**Amendments to the Drawings:**

**REMARKS/ARGUMENTS**

Claims 1 through 2 and 4 are pending in the present application. Replacement drawings received on June 27, 2005, were disapproved because of informalities. A new set of drawings providing formalized numbering has been provided and applicant respectfully asks for approval of the attached drawings.

*Fig. 1A*

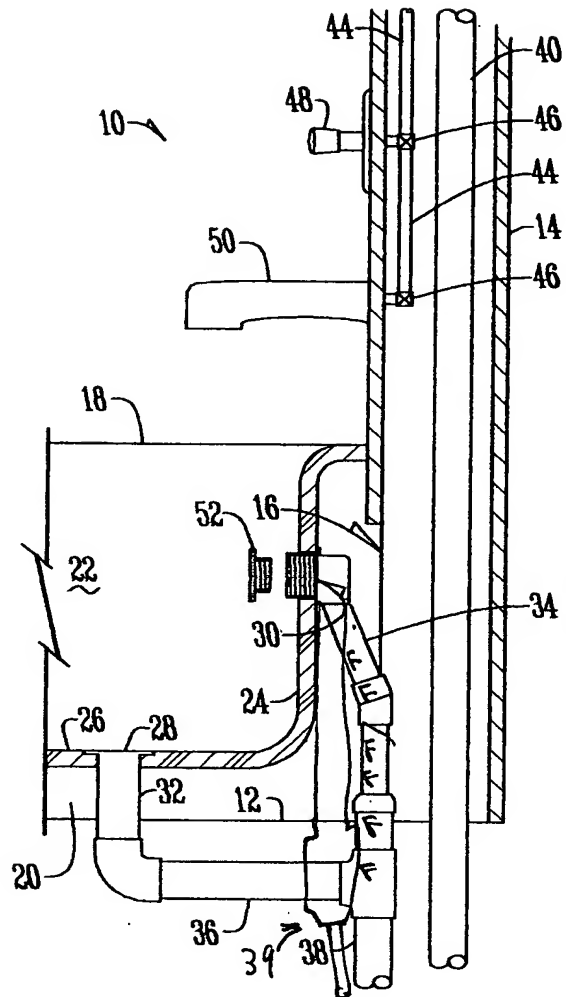
The attached sheets of drawings include changes to Page 1 and Page 2 with changes to Fig. 1A and Figs. 2 and 3. In Fig. 1A the drain pipe 34 is drawn as L-shaped consistent with Fig. 3 and numerals have been added. In Figs. 2 and 3, numerals have been added.

Once again, Fig. 3 shows the inverted L-shaped drain pipe with a horizontal leg 37A and a vertical leg 37B. Furthermore, Fig. 1A has been amended to show the embodiment of Fig. 3 wherein the drain pipe has an inverted L-shape wherein the horizontal leg extends through the overflow port and the vertical leg extends downwardly for connection to a fluid drain system.

The drawings have also been objected to as not showing "a fluid drain system". As discussed above, a numeral has been added to Fig. 1A showing the fluid drain system that was provided in the drawings of the original application. The specification has also been amended to call for the fluid drain system as described in the original claims. Thus, the drawing objection is considered overcome.

Fig. 3

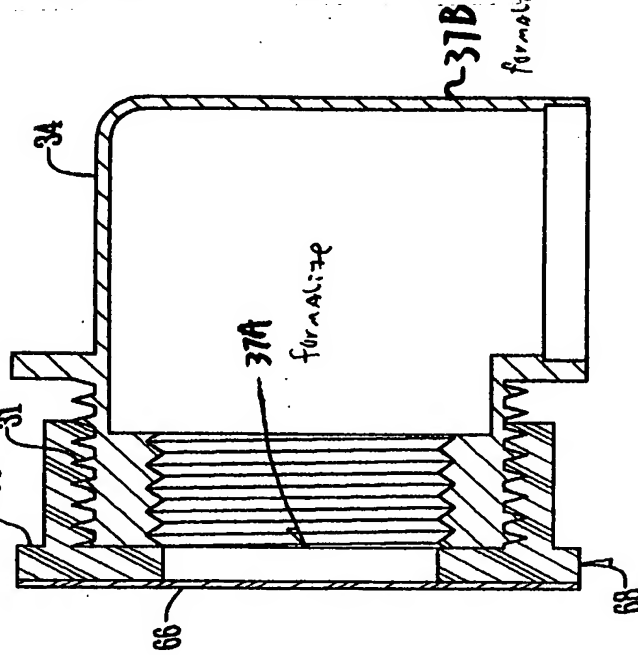
The drawings are objected to under 37 CFR § 1.83(a) as not showing every feature of the invention specified in the claims. First the Examiner asserts that the drawings do not show "a drain pipe having an inverted L-shape" as called for by claim 1. Applicant directs the Examiner's attention to Fig. 3 that shows a drain pipe 34 with an inverted L-shape having a horizontal leg 37A and a vertical leg 37B. Fig. 1A has been amended to specifically show this embodiment of the invention in all of the Figures. Thus Applicant asserts that the figures do show a drain pipe having an inverted L-shape and respectfully requests the drawing objection be withdrawn.

The Examiner has also objected to the drawings as not showing "a sealing material is composed of a material capable of sealing the first end when the cap is threaded onto the first end". This limitation has been amended to require "the cap threadably mounted on the externally threaded portion of the first end such that the cap is sealed against the overflow port when the cap is threaded onto the first end". This amendment gains its antecedent basis in the specification at page 4, lines 14 through 18 that state "a thin sealing membrane 66 is affixed to the face 54 (Fig. 2) of cap 52 so as to seal the aperture in the cap when it is screwed into the threads 31 so that the cap can be effectively sealed against the port 30". Thus no new matter has been added. Additionally, Fig. 3 shows this sealing
